CITY OF AUSTIN – DEVELOPMENT SERVICES DEPARTMENT
SITE PLAN APPLICATION – MASTER COMMENT REPORT

CASE NUMBER: SP-2019-0297C
REVISION #:
CASE MANAGER: Jeremy Siltala
UPDATE: U0
PHONE #: (512) 974-2945

PROJECT NAME: 218 South Lamar
LOCATION: 218 S LAMAR BLVD SB /W UNITS

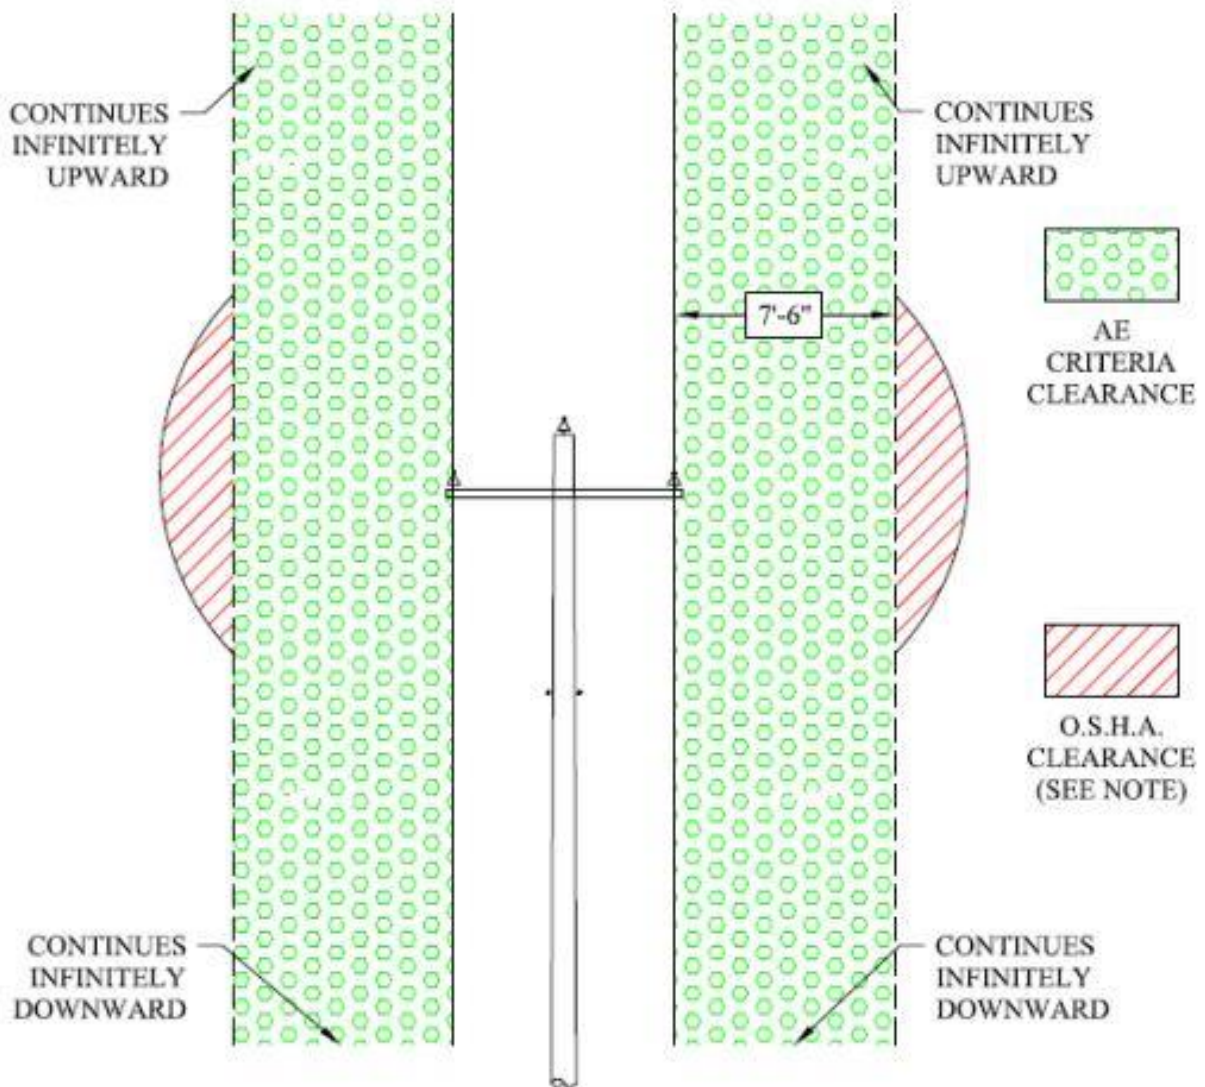
EL2. There is existing overhead facilities with a partial easement currently serving the adjacent property and the following clearance is required and needs to be shown and clear of the existing easement.

- **1.10.2 Minimum Working Clearances from Energized Overhead Electric Utility Lines**
- **1.10.3 Permanent Clearances from AE Overhead Lines and Facilities**

See the Austin Energy Permanent Clearance Envelopes and the OSHA/TxHSC Working Clearance Envelopes shown in the diagram below and in the Appendix C - Exhibits, Figures 1-34, 1-35, and 1-36. (Also see Section 1.10.6 for service drop clearances and Section 1.10.7 for clearances from swimming pools). These include, but are limited to, clearances from Customer's buildings, parking garages, light poles, signs, billboards, chimneys, radio and television antenna, tanks, and other installations. As required by AE Design, the Customer shall provide AE with a survey showing the proximities of the Customer's existing and/or proposed facilities to existing AE primary voltage facilities. For more information, contact AE Design.

Figure 34:

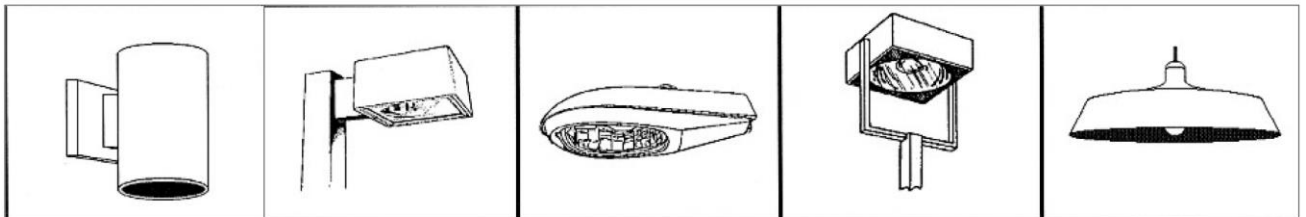
- SP3. Include the following note on the site plan page: "All exterior lighting will be full cut-off and fully shielded in compliance with Subchapter E 2.5 and will be reviewed during building plan review. Any change or substitution of lamp/light fixtures shall be submitted to the Director for approval in accordance with Section 2.5.2.E." Include Figure 34 showing examples of fully-shielded fixtures:
